FOR PERCOLATION TESTING AND SITE EVALUATION

RE: PERCOLATION TEST RESULTS, 2461 Mullinix Mill Road, Clevenger Farm, A529576

PERCOLATION CERTIFICATION PLAN
CLEVINGER FARM
 LIBER 11322 AT FOLIO 370
 2461 MULLINIX MILL ROAD
 ELECTION DISTRICT No. 4
 HOWARD COUNTY, MARYLAND
 SCALE: 1" = 100' NOVEMBER, 2008

PC 529576

LOCATION DIAGRAM

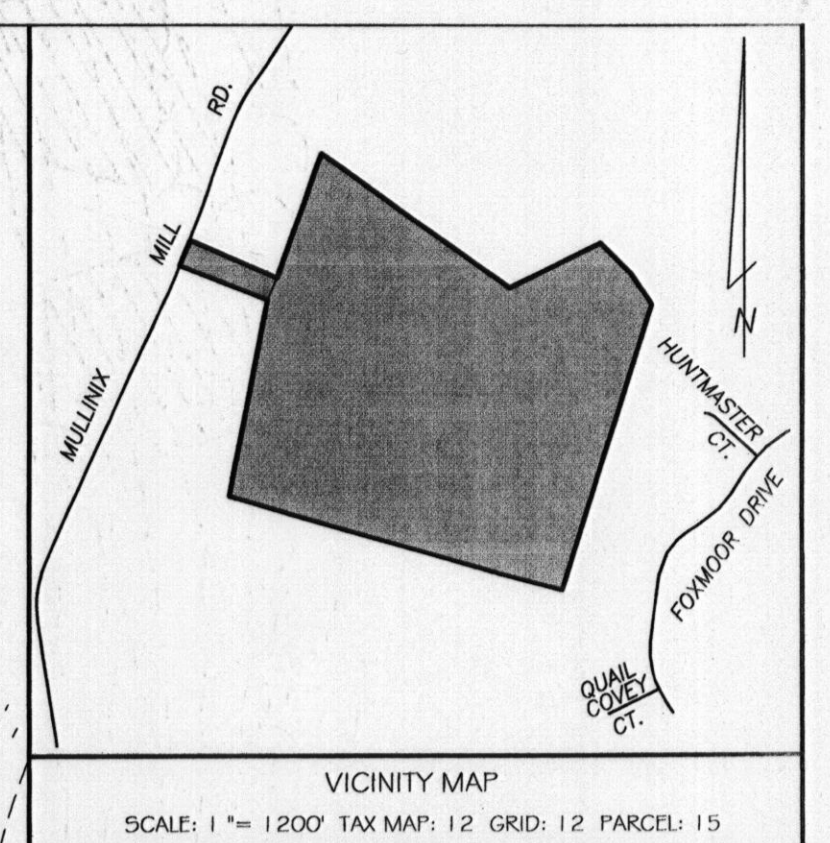
COMMENTS: Locate 13 new Perc Tests, the

Pole Barn, 2 new LP Tanks, and the well

at #2445. Also, ~~if possible~~ show planned driveway

location.
